SUBJECT: R.E. Ginna Nuclear Power Plant
Docket No. 50-244

**Response to Requests for Additional Information Regarding Topics
Discussed on Conference Calls for Extended Power Uprate (EPU)**

ATTACHMENT 1
QUESTIONS AND ANSWERS RESULTING FROM A FEBRUARY 23, 2006
CONFERENCE CALL

Figure 2-1

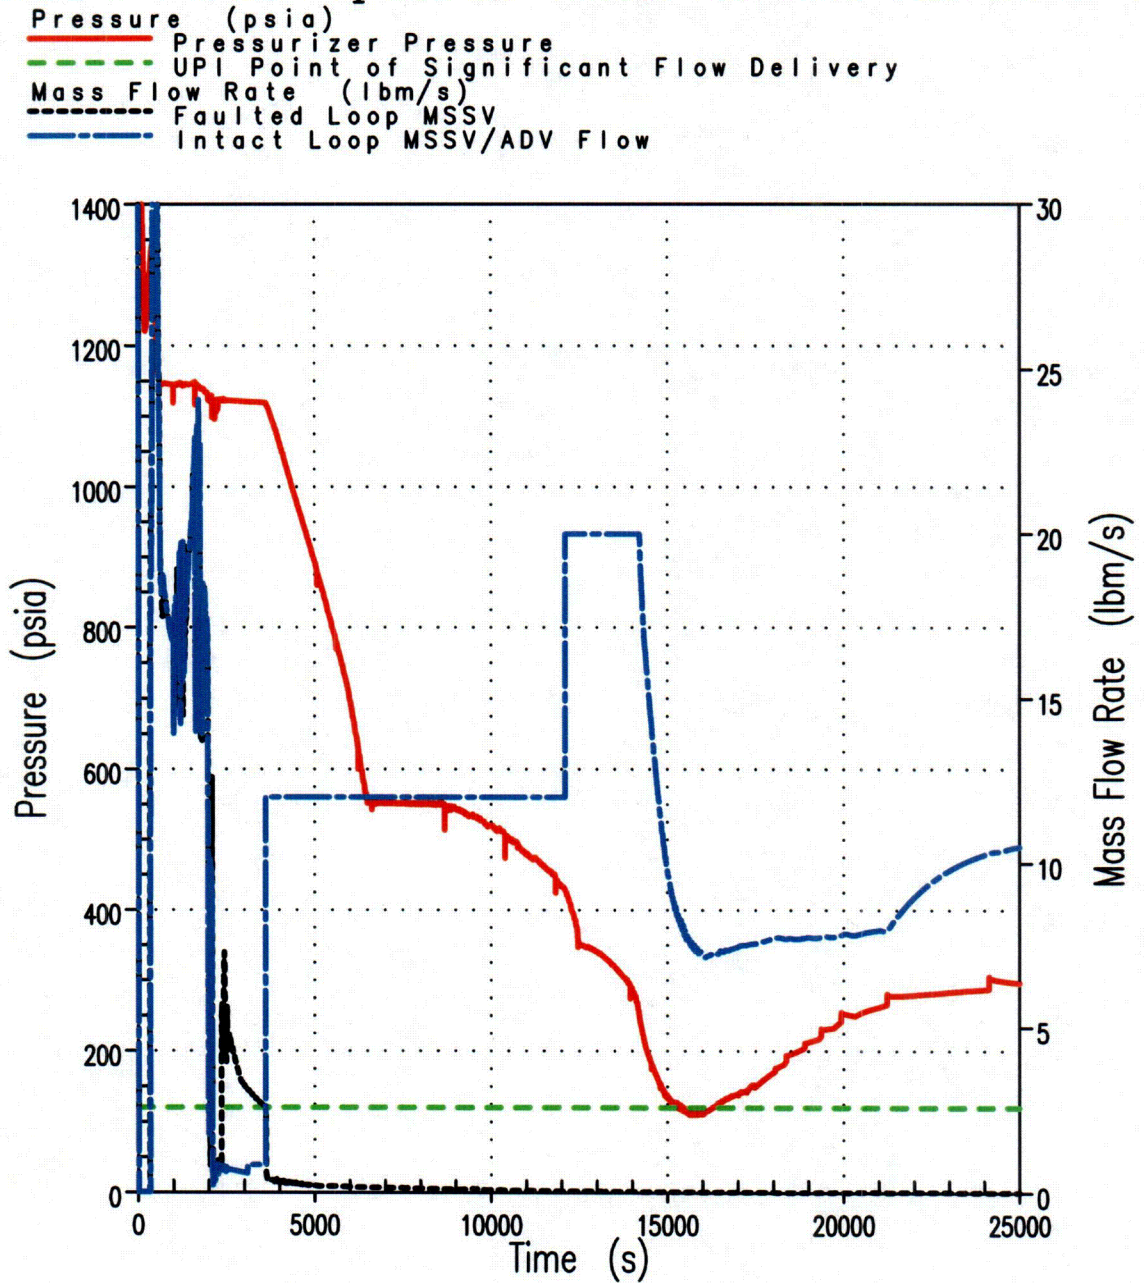
- 2) *Furthermore, a failure of one of the ADVs also indicates that RCS pressure may not be able to be reduced to less than 140 psia within 5.5 hrs (i.e. the cooldown is initiated at no later than one hr post-LOCA). As such, the licensee should provide analysis of alternate depressurization options to show that should one of the ADVs fail to open, use of the pressurizer PORVs, for example, would demonstrate success. This could be demonstrated by showing actuation of the PORVs and an RCS pressure less than 140 psia before 5.5 hours post-LOCA. The staff only mentions this option as an example of a potential success path. The licensee is requested to identify the alternate means for depressurizing the plant in the event one of the ADVs fails to open and demonstrate the success through an analysis (i.e. show RCS pressure can be reduced below 140 psia prior to 5.5 hrs) of the limiting break.*

Failure of one steam generator atmospheric dump valve (ADV) will not limit RCS depressurization as indicated. Additional analysis which assumes only one ADV shows that the RCS can be brought to 120 psia in less than the 5.5 hour time frame allotted. The 120 psia RCS pressure is chosen since at that head, the RHR pump(s) will start to deliver significant flow rate. Cut-in pressure is 140 psia. This is accomplished by increasing the steaming rate for the operable ADV at an appropriate time frame to adhere to the 100°F/hr cooldown rate (but within the capacity of the ADV). As shown in Figure 2-1, RCS pressure reaches 120 psia at approximately 15,400 seconds (4.3) hours.

Figure 4-1 Broken Loop Hot Leg Liquid Mass Flow Rate

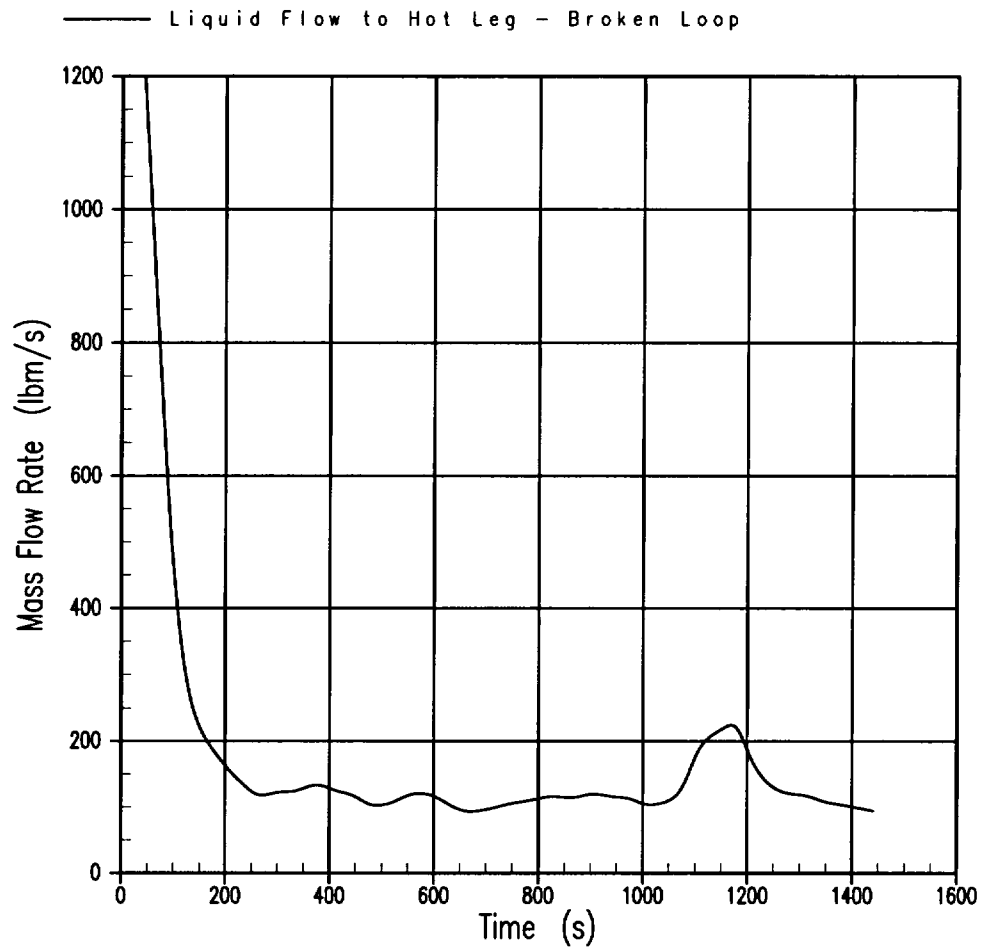
- 4) *Staff transient calculations show that precipitation occurs at about 4.5 hrs compared to the 6 hr and 13 minute precipitation time for the limiting LBLOCAs. The staff calculations utilized the same data the licensee utilized in the 6 plus hour calculated precipitation time. This precipitation timing difference needs to be resolved before final approval of the power uprate. It is noted that the staff model is a transient calculation that balances the loop pressure drop with the hydrostatic fluid balance between the downcomer and inner vessel region (including a detailed drift-flux model to compute the time varying mixture volume in the inner vessel). This model has been previously benchmarked against low pressure level swell data and was utilized in the AP1000 and Waterford EPU safety analysis reviews.*

My earlier precipitation time relative to your calc is due to the assumption that boiling in the core begins at the start of reflood. Since you delay boiling for the first 24 minutes your concentrations are much lower, and precipitation is much delayed. I calc a precipitation time of 6 hrs 15 minutes your assumption; this reproduces your calc for the LBLOCA. I do not agree with your assumption that the ECCS will terminate all boiling for the first 24 minutes following an LB LOCA; the vessel walls are 500 - 600 F and the core will contain large amounts of stored energy at the start of reflood. I would suggest you repeat your calc without this assumption. If you allow the core to boil at the start of reflood, you should expect to reach the precipitation limit of about 29.2 wt% at about 4.5 hrs. Can you recommend the realignment of HPSI at 4 hours? This is consistent with most of CE NSSS designs as they have switch times in the 4 hr time period at the higher power level or EPU conditions.

1. From the beginning of reflood onward, there is significant liquid flow out the hot leg break (Figure 4-1).
2. After 100 seconds, UPI water travels down into the low power, outer core regions. At the same time there is significant upward flow in the center, high power core region (Figure 4-2). This indicates sufficient circulation such that the core and upper plenum are well mixed. These core flow patterns are consistent with those observed in the CCTF Core-II large scale tests (Runs 076 and 072) summarized in Reference 4-1.
